Comments On Proposal To Shift Link Budget Of 25GBASE-ER By +2.8 dBm To Accommodate PIN Receivers

20170111

Kohichi Tamura

Comparison Of Link Budgets For 25GBASE-ER – Current And Newly Proposed (25GBASE-LR also shown for reference)

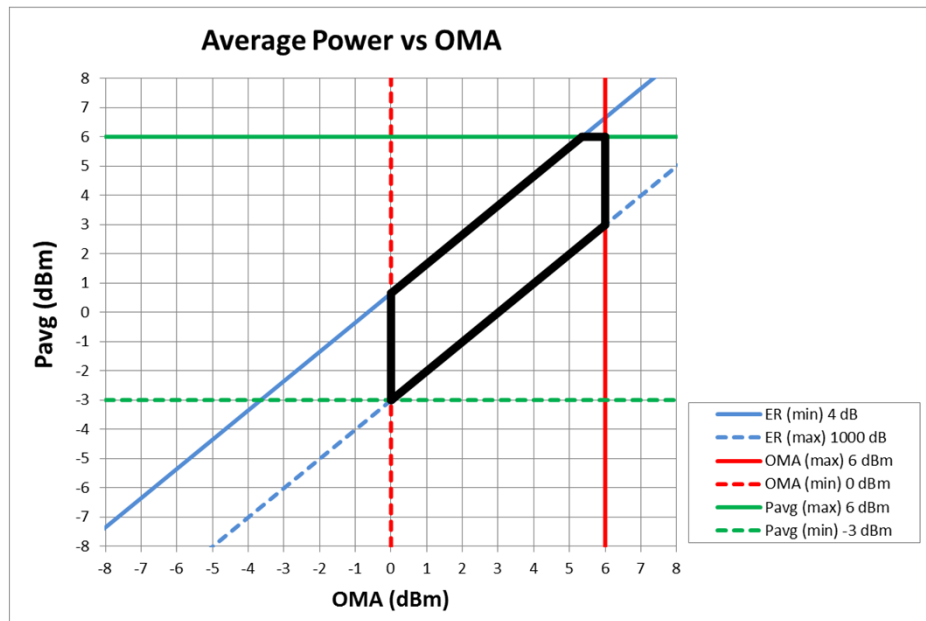
- Some points to consider when raising Tx OMA (min) to 2.8 dBm to accommodate PIN Rx.
 1. Narrowing of Tx power range without corresponding increase in Tx OMA (max).
 2. SBS limitation on maximum power.
 3. Practical limits on TOSA power (especially at high T).
- This presentations examines 1 and 2.

Comparison of 25GBASE-ER Tx OMA vs P_{avg} for ER (max) = INF

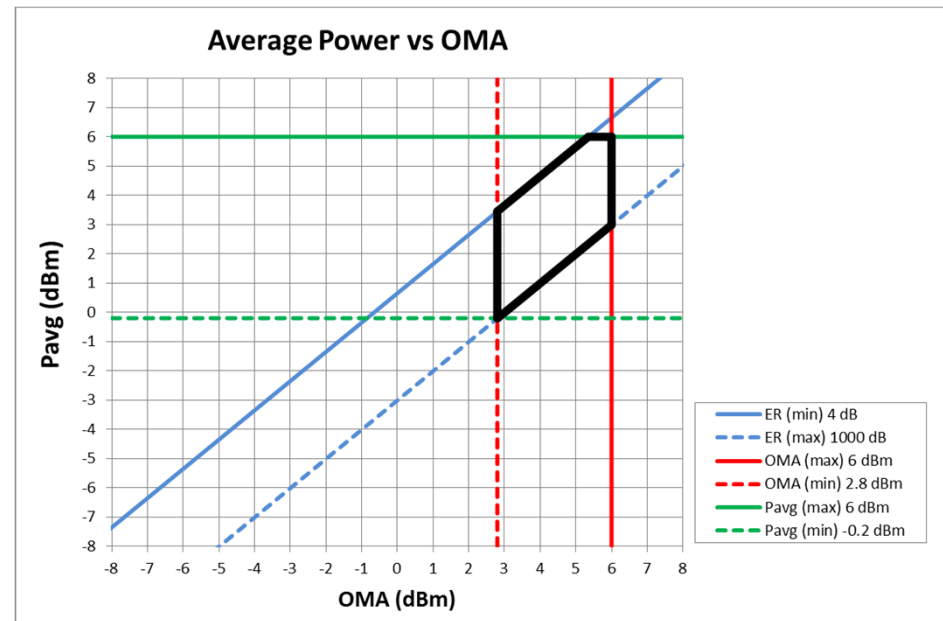
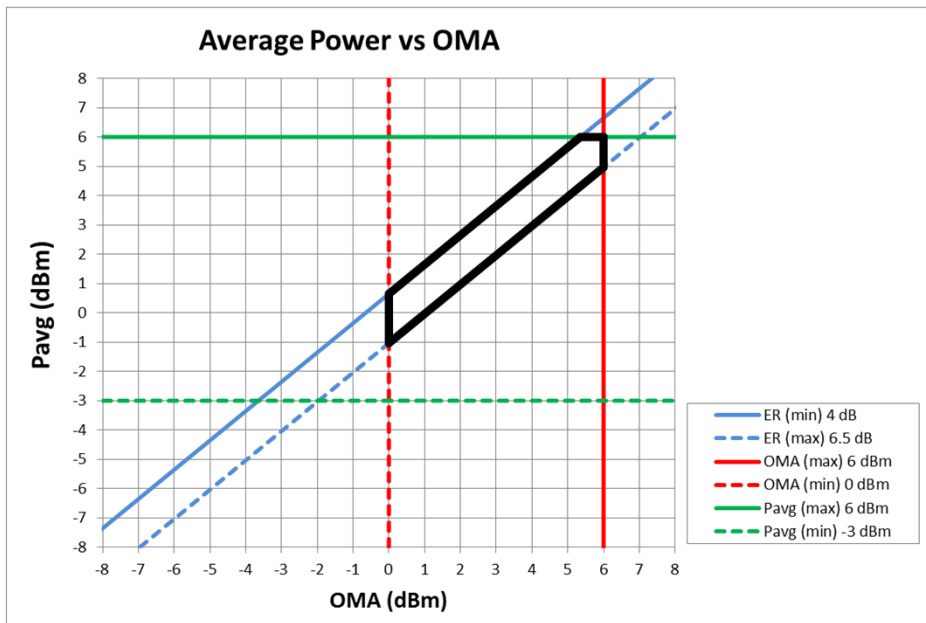
Note: "Infinite" ER (max) can not be realized in practice.

Comparison of 25GBASE-ER Tx OMA vs P_{avg} for ER (max) = 6.5 dB

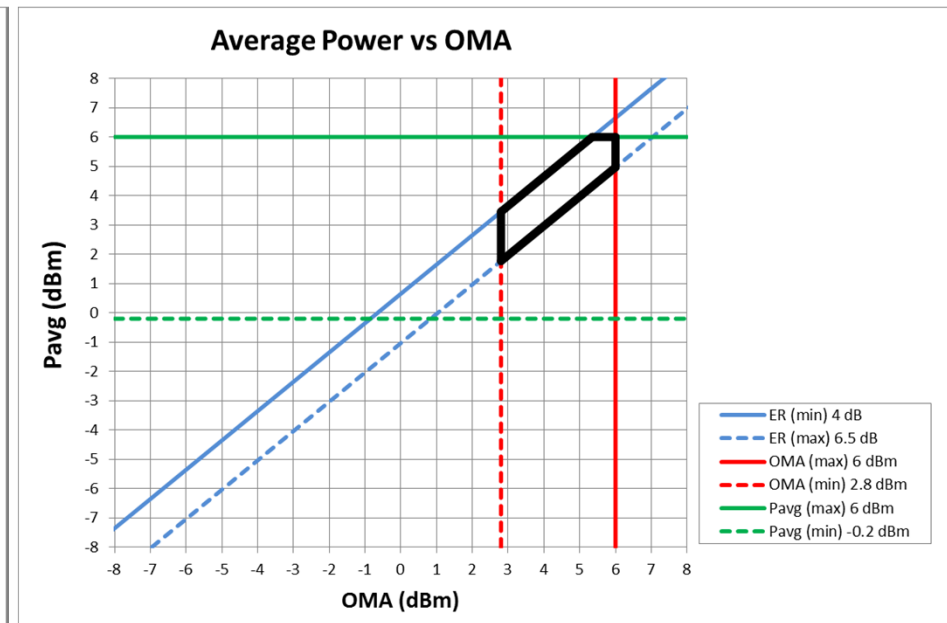
Note: ER (max) of 6.5 dB is realistic for DML transmitters.
